1. PCI Engineering Change Request - Addition of 3.3Vaux signal to Connector

TITLE:	Addition of 3.3Vaux signal to Connector
DATE:	May 21,1997 (Last update: 10/27/97)
AFFECTED DOCUMENT(S):	PCI Local Bus Specification, Revision 2.1, June 1, 1996 PCI Bus Power Management Interface Specification Revision 1.0
SPONSOR:	Gary Solomon, Intel Corporation

Figure 1. B3 Reset Timing

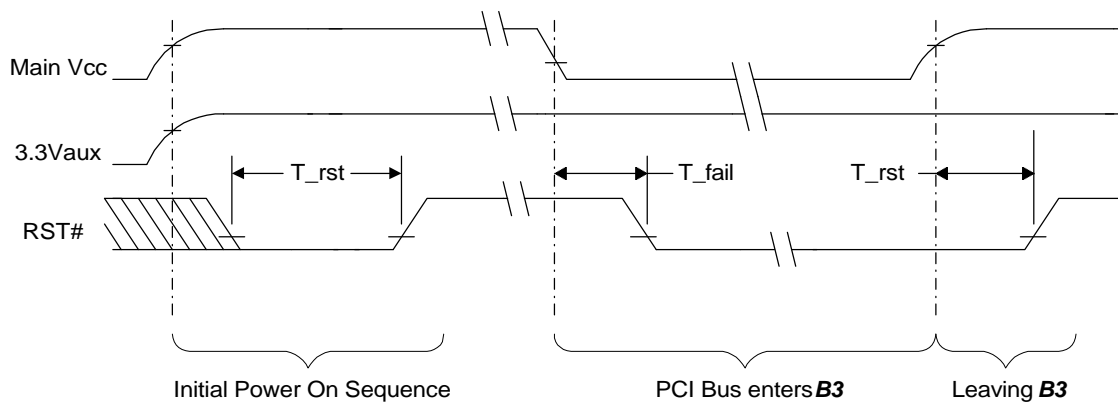
The following diagram illustrates the required behavior of RST# when the bus transitions into, and out of **B3**. Refer to the “Reset” section of the PCI Local Bus Specification for existing RST# requirements.

- **The central resource of systems that support 3.3Vaux must ensure that the PCI RST# signal remains asserted whenever the PCI bus is in the B3 state.**

This can be accomplished either by powering the PCI RST# output buffer with auxiliary power, or by deploying a weak pulldown resistor on the RST# signal (on the motherboard) such that when power is lost at the RST# output buffer the signal network will have a low impedance path to ground. With RST# asserted whenever the bus is in **B3**, PCI functions that are in the **D3_{cold}** state can depend on the low to high transition of RST# as a reliable indication that they must internally initialize all volatile portions of their function and transition themselves to the **D0_{uninitialized}** state.
